## CHAPTER 3 – REVISIONS, CLARIFICATIONS, AND CORRECTIONS TO THE DRAFT EIR

Harvard-Westlake River Park Project

**Figure II-26**  
Below Grade Plan for the Project

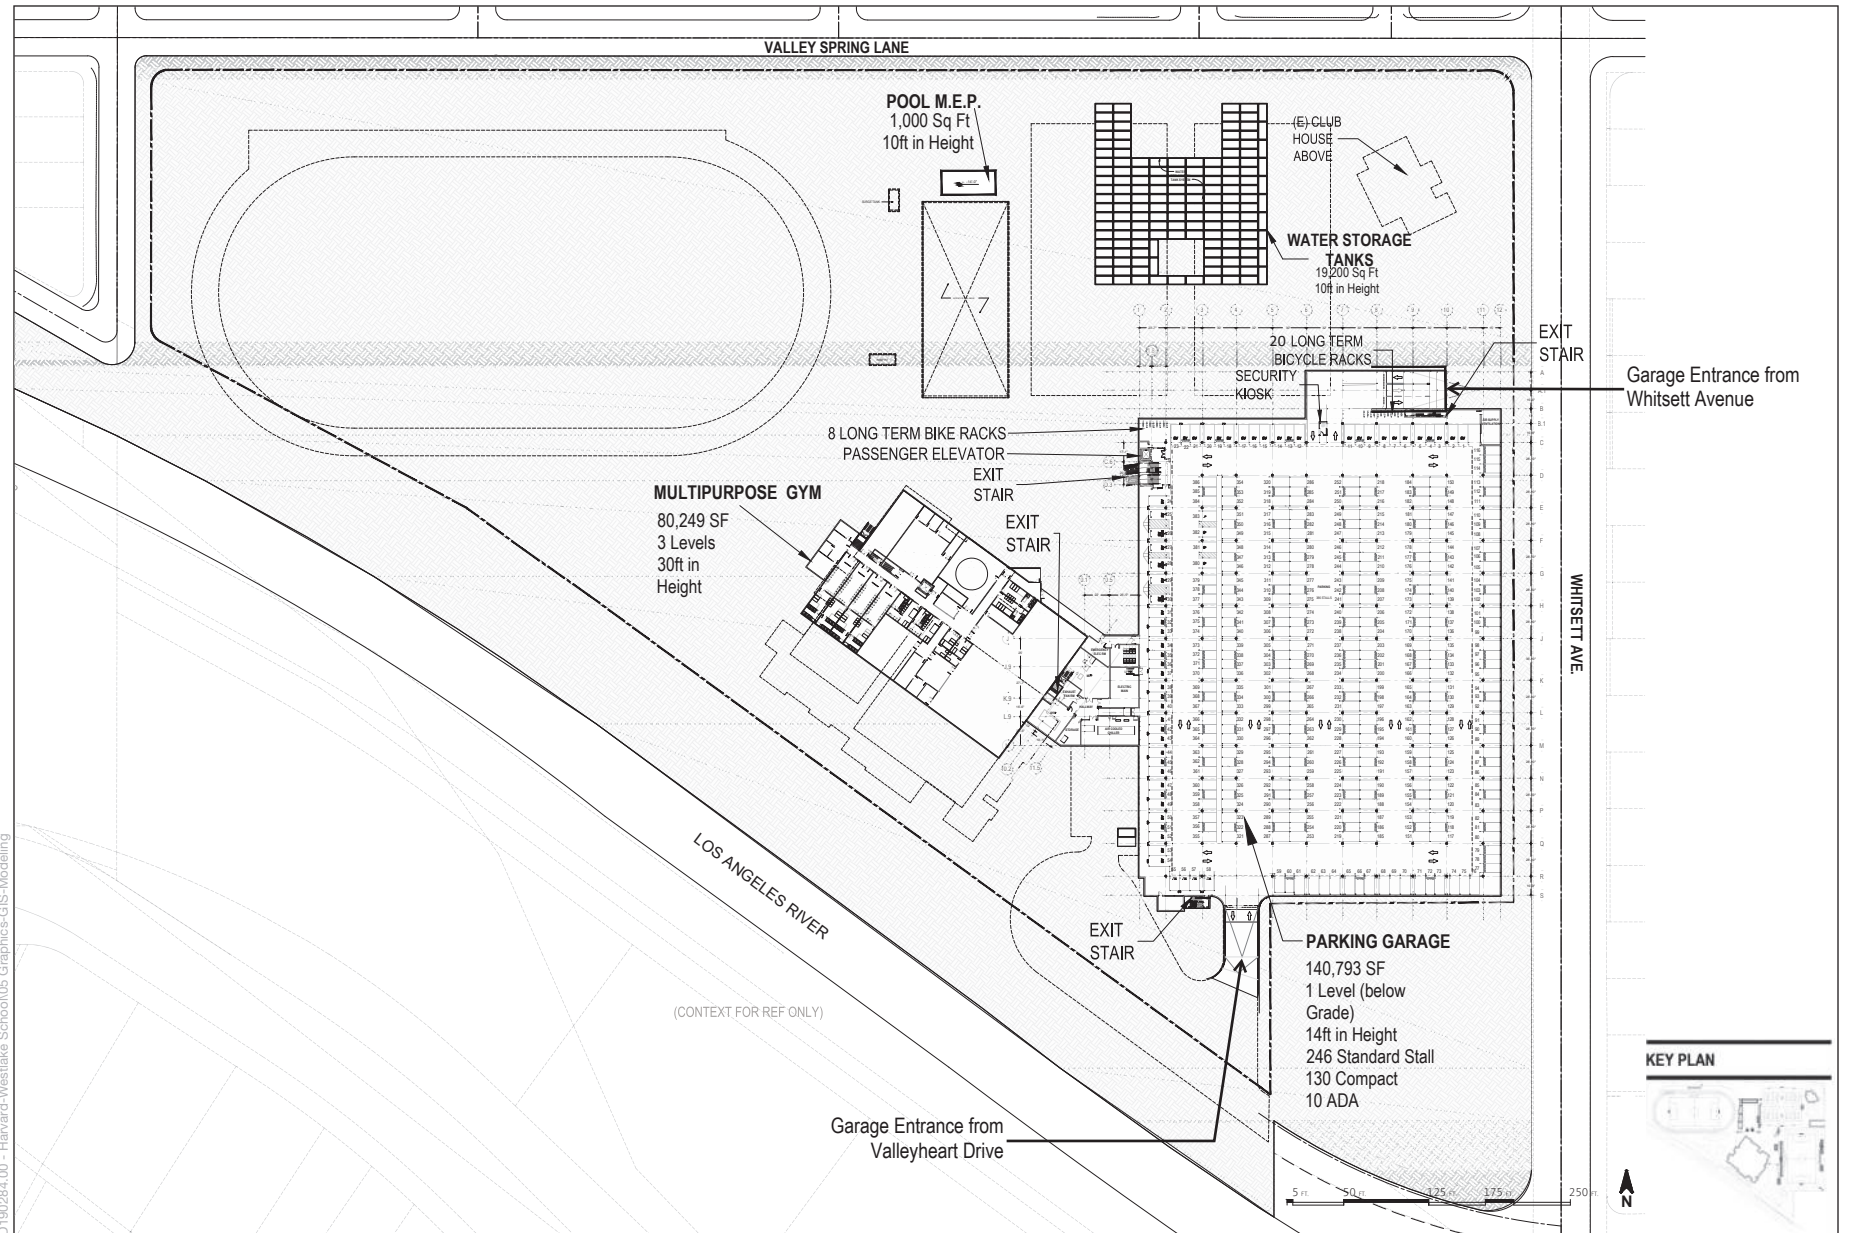
35. Page II-54, Figure II-26, *Below Grade Plan for the Project*, is updated to show the Project's reduced subterranean parking spaces and size of the structure, including the increased setback of the building footprint relative to the gymnasium and property line. The figure is also updated to show the removal of the tennis stairs and elevator and the reduction in size of the stormwater capture system.

**Figure II-27**  
Light and Signage Plan for the Project

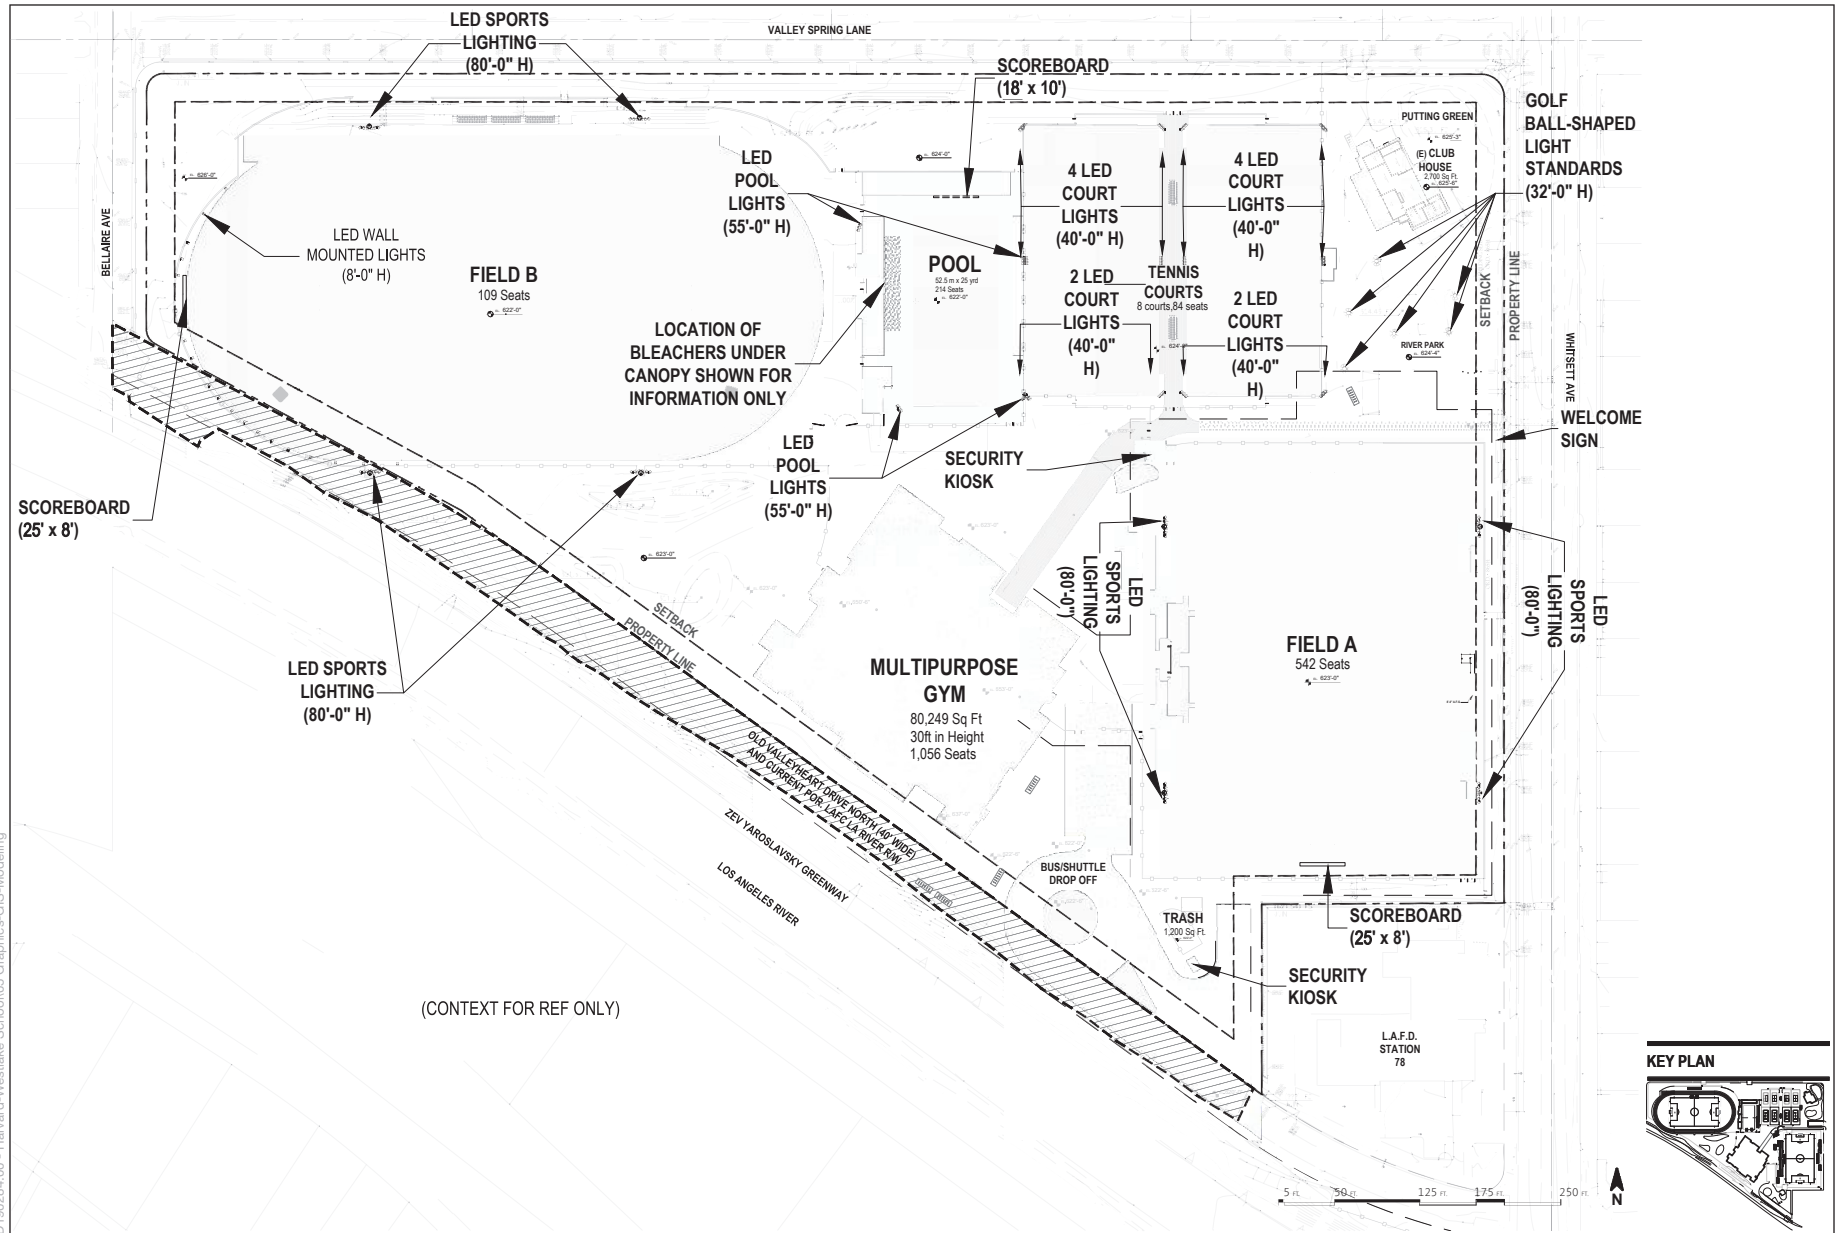
40. Page II-58, Figure II-27, *Light and Signage Plan for the Project*, is updated to show removed and relocated light poles, consistent with the overall reduction in the Project's lighting program and changes in light pole heights. It is also updated to show revisions to the number of bleacher seats throughout the Project Site and reduction in the size of the pool canopy.

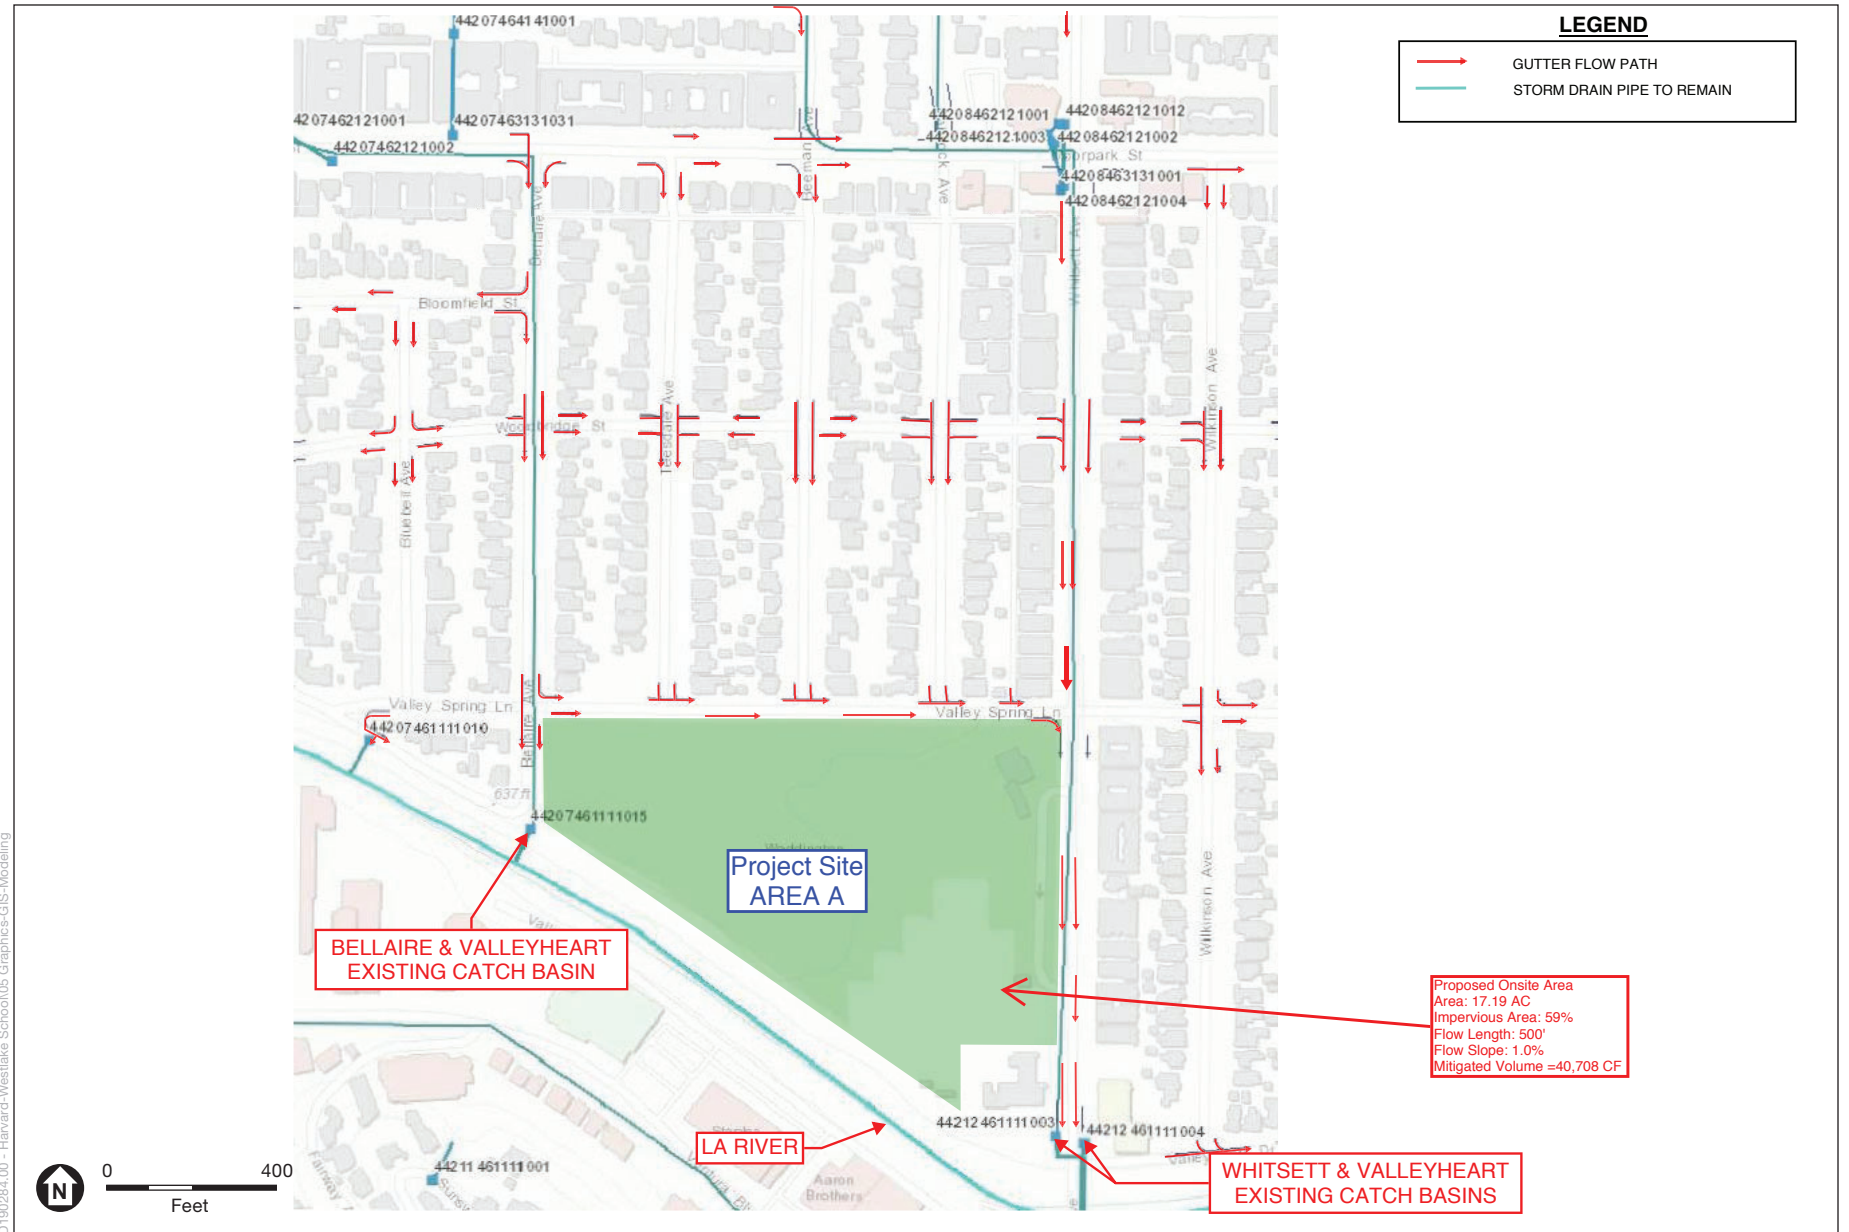
6. Page IV.I-31, Figure IV.I-2, *Proposed Site Drainage*, is updated to remove the offsite drainage area (Area B).

Figure M-3

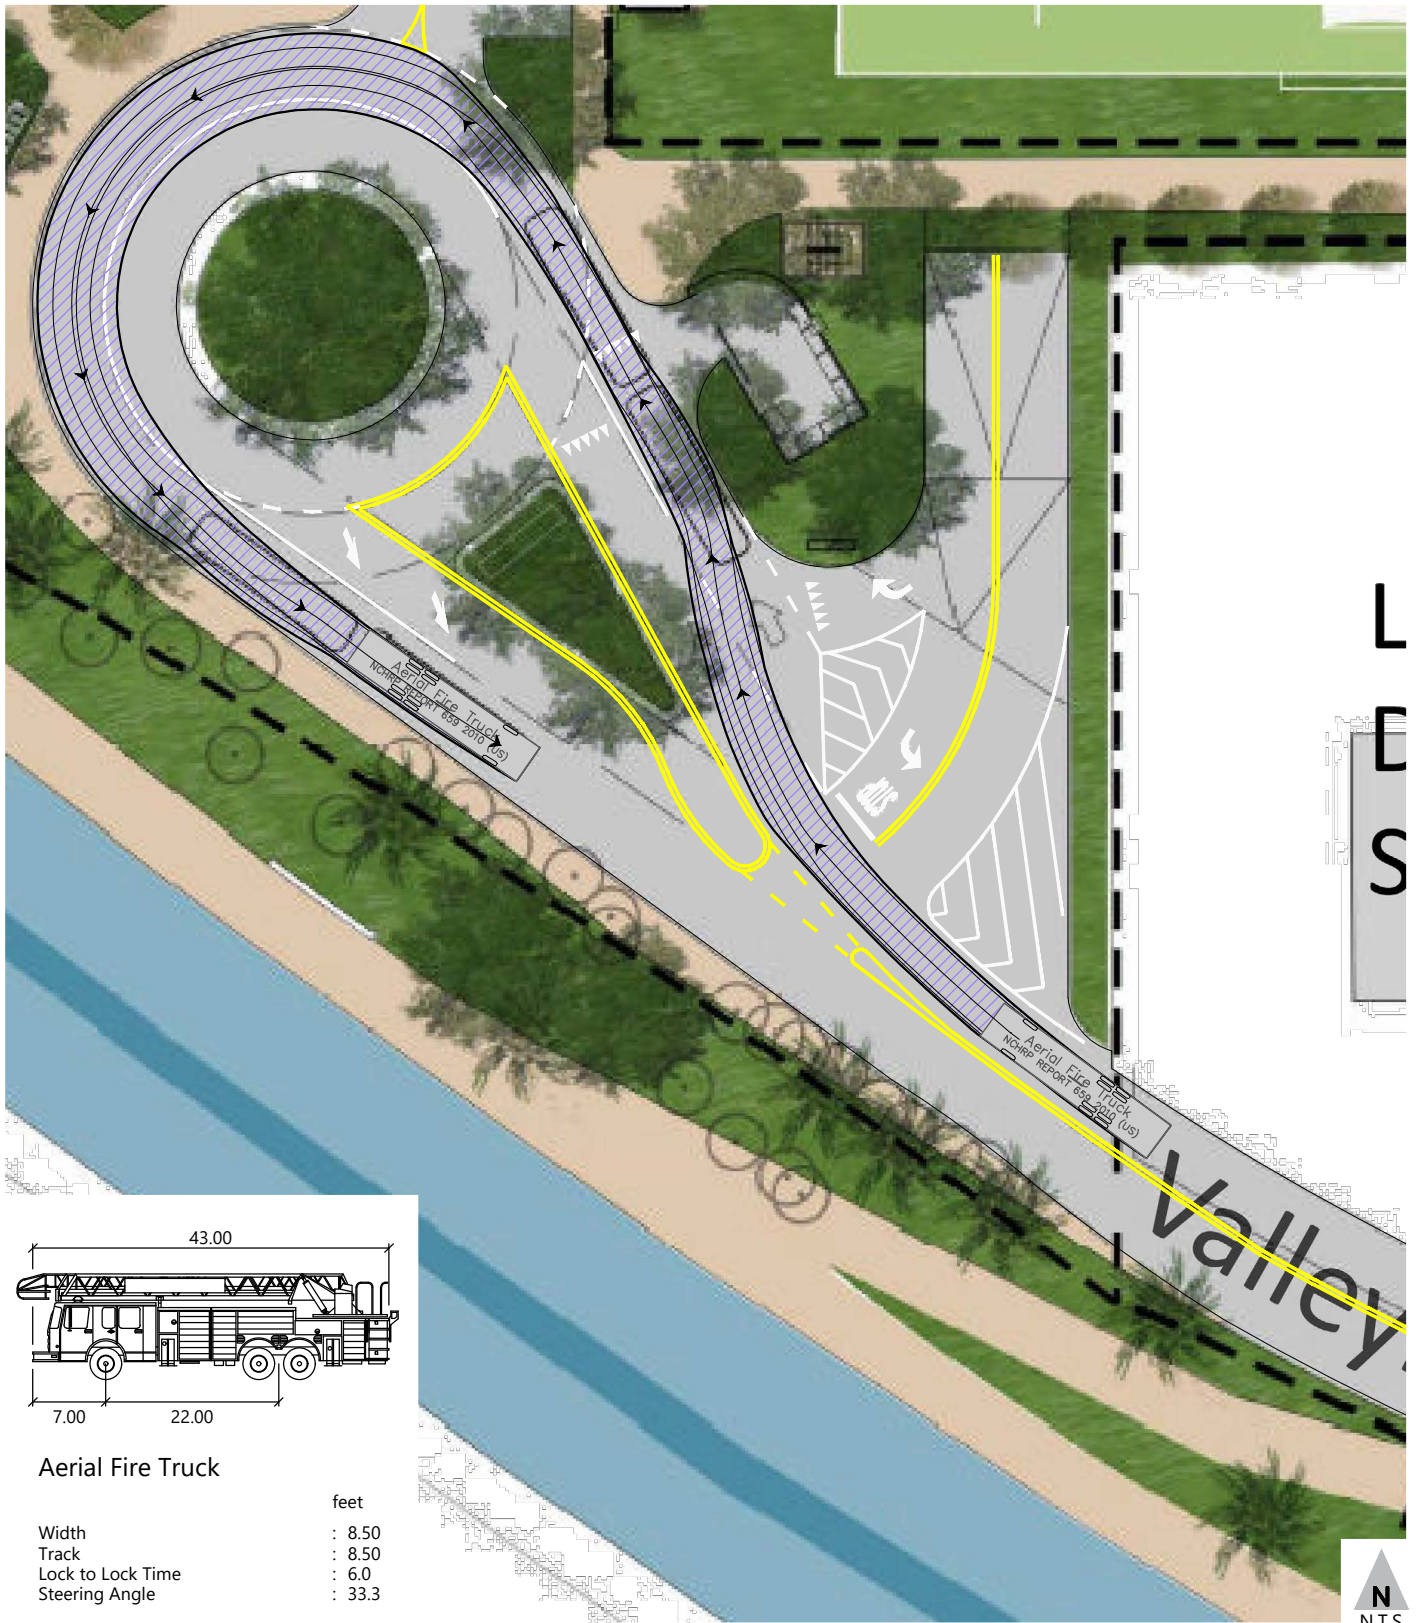
**Figure M-3, Fire Truck (NCHRP Report Aerial Fire Truck) Autoturn**, illustrates that adequate space is provided in the Project’s roundabout to accommodate the full radii of turning fire trucks.
